**RESOURCE CONSENT DECISION:  
165383**

<b>APPLICANT:</b>	GW Wilfield Ltd
<b>PROPOSAL:</b>	To change conditions 2, 3, 8, 9, 27, 48 and 68 of resource consent 145470 (as amended by 155098, 155417 and 155584)
<b>LOCATION:</b>	West Coast and Weedons Ross Roads, West Melton
<b>LEGAL DESCRIPTION:</b>	Rural Section 37879 being 25.1462ha in area more or less, as contained in Certificate of Title CB549/209  Rural Section 37783 being 64.2186ha in area more or less, as contained in Certificate of Title CB11A/748  Lot 2 DP 391578 being 2.8549ha in area more or less, as contained in Certificate of Title 367736
<b>ZONING:</b>	The property is zoned Living 2 and Living 2A under the provisions of the Partially Operative District Plan (Townships) Volume and Inner Plains under the provisions of the Partially Operative District Plan (Rural) Volume.
<b>STATUS:</b>	This application has been assessed as a variation of conditions pursuant to Section 127 of the Resource Management Act 1991 in respect of subdivision consent 145470 granted on 16 January 2015 to undertake a subdivision in three stages to create 158 residential and rural-residential lots and a balance rural lot, with roads and reserves to ve

**DRAWING No.:** C.18130 **SHEET No.:** 1 OF 6 **R28**

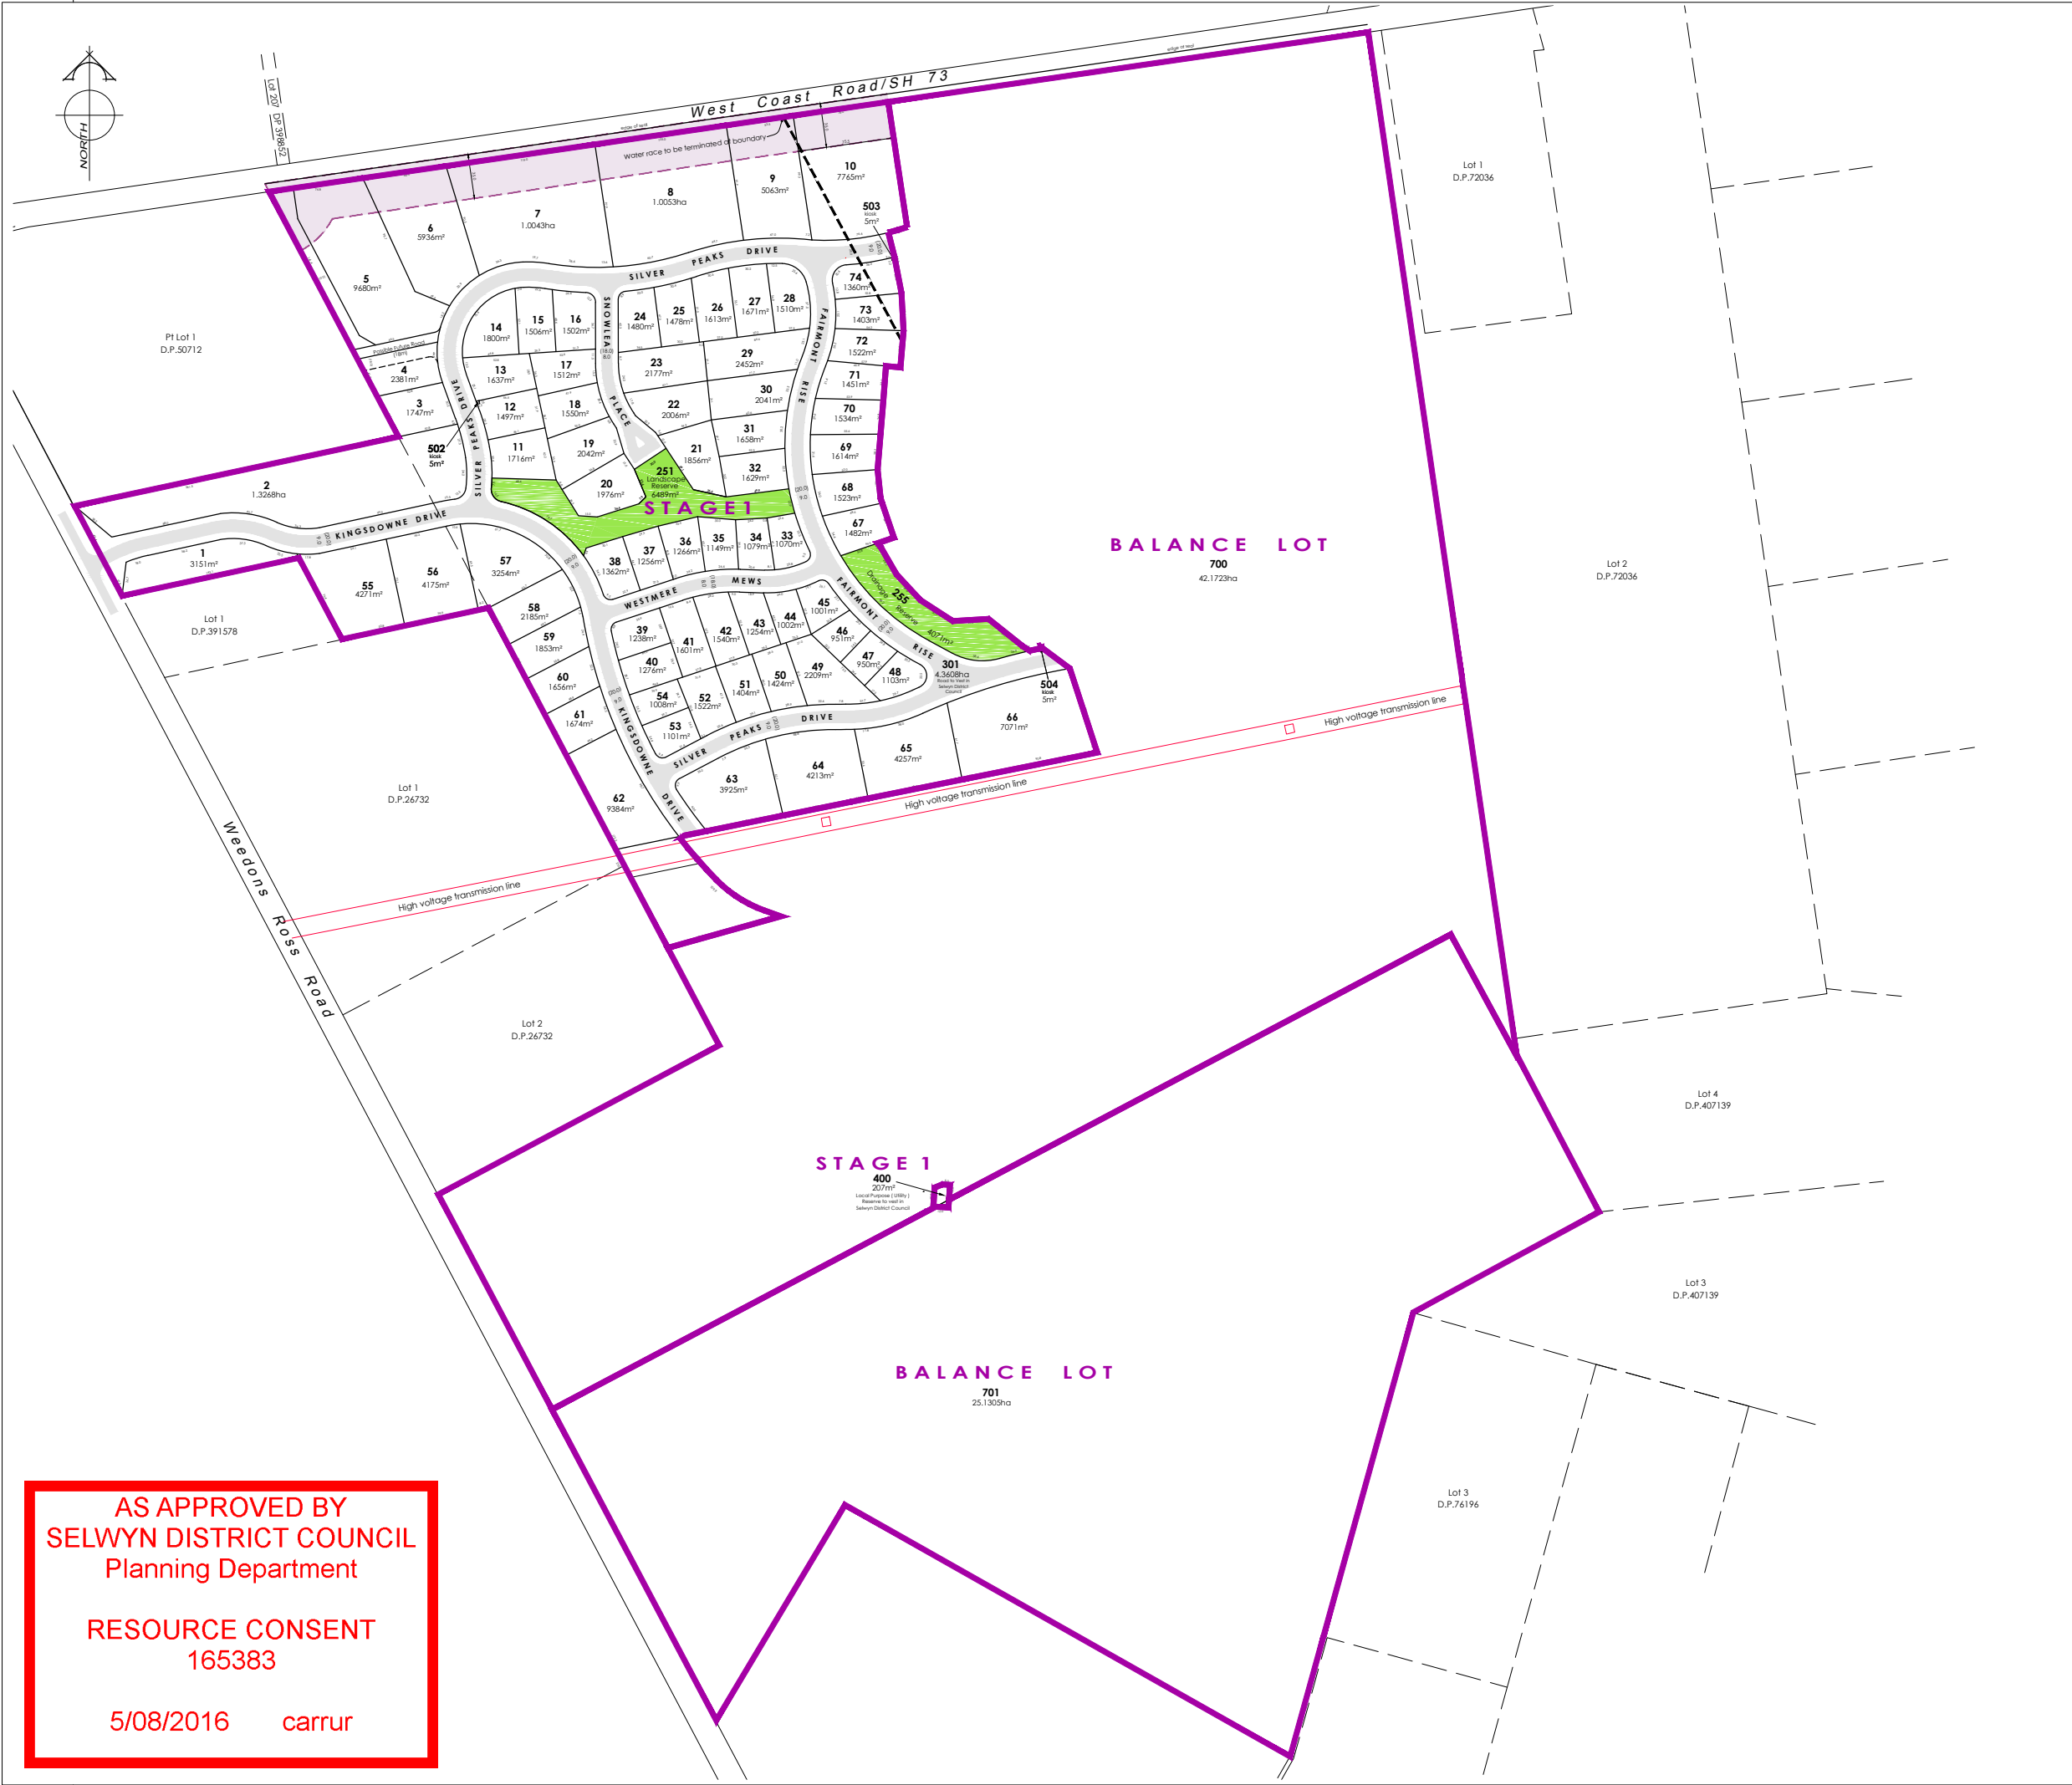
*That the subdivision shall proceed in general accordance with the attached approved subdivision plans (Davie, Lovell-Smith, Drawing C.18130 Sheet 1 Revision **28** dated*

**July 2016** and Sheets 2 – 5 Revision **R6**, all dated August 16) and the details included with the application, including the creation of any additional balance lots and utility lots required, except where varied by the following conditions of consent.

CAD FILE: J:\18130\SUBCON\SWALE NETWORK\_RS.dwg REVISION:  
 DRAWING No: SHEET No:  
**C.18130** **R5**

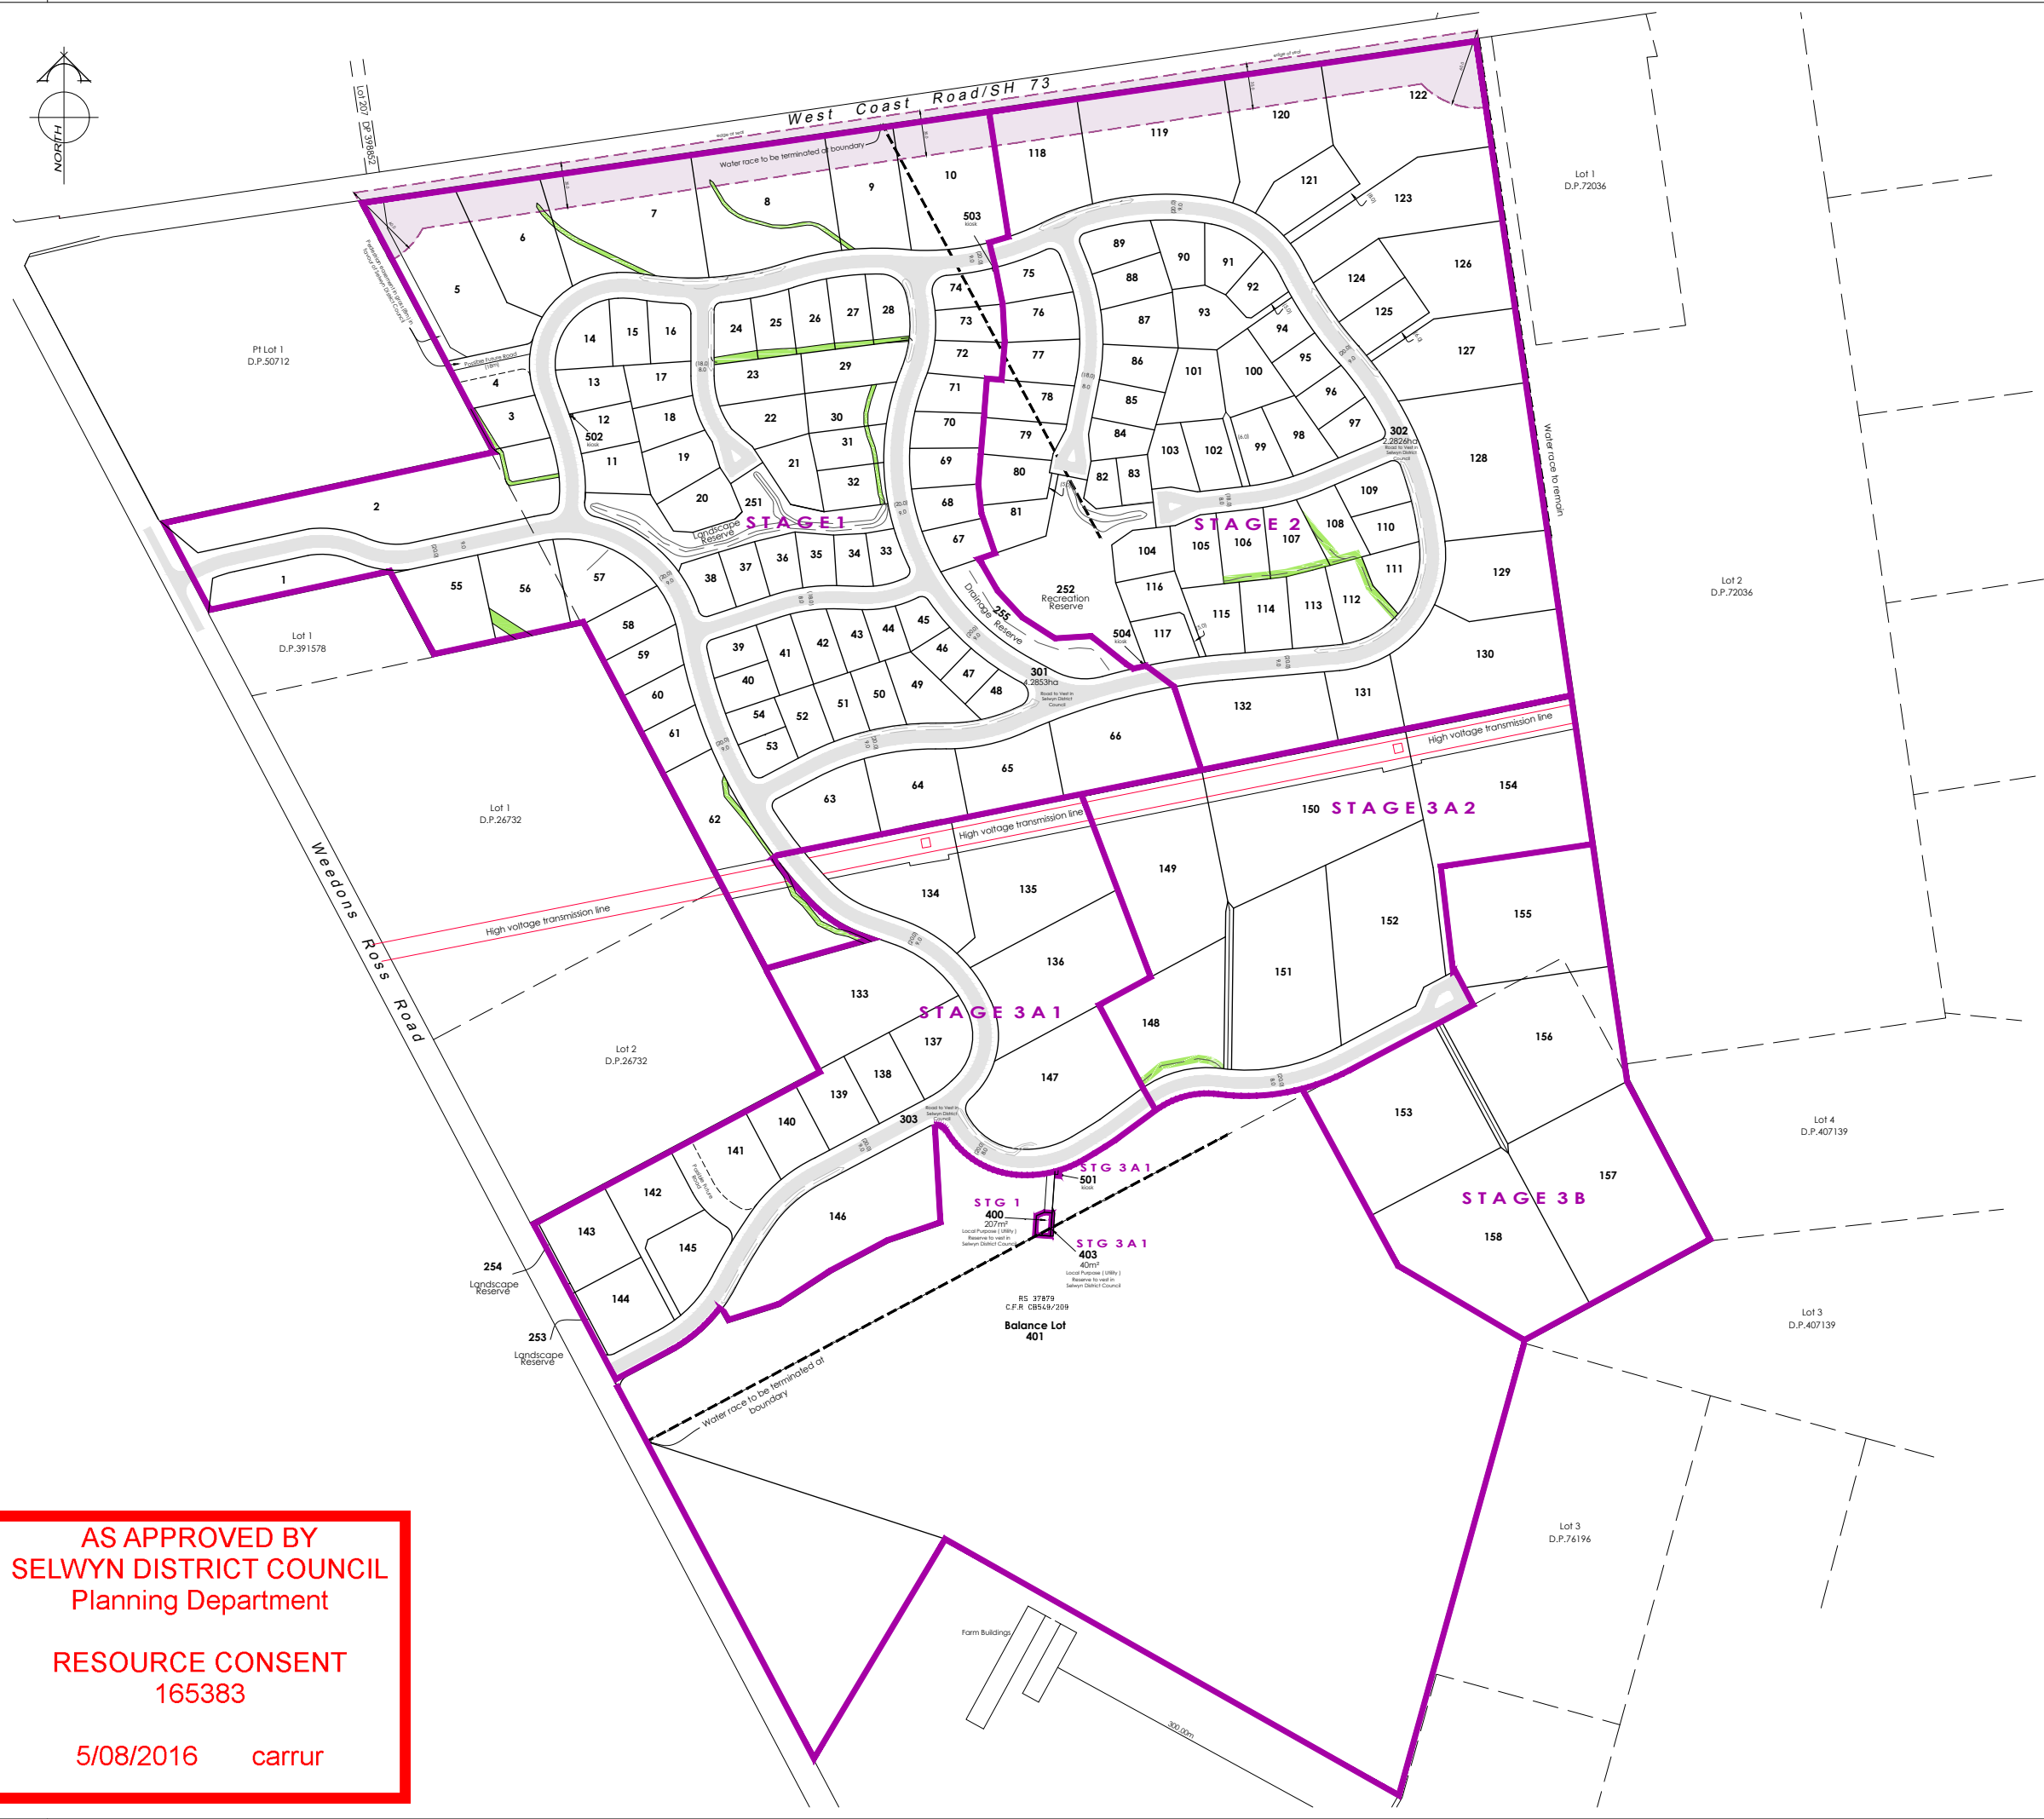
- c. That the land comprising Stormwater Flow Paths, indicated on Proposed Swale Network plan 'swale\_network\_R5.dwg', shall be separately shown on the survey plan. This area shall include the area measured from the point at which a horizontal line 200mm above the invert level of the swale touches the banks.
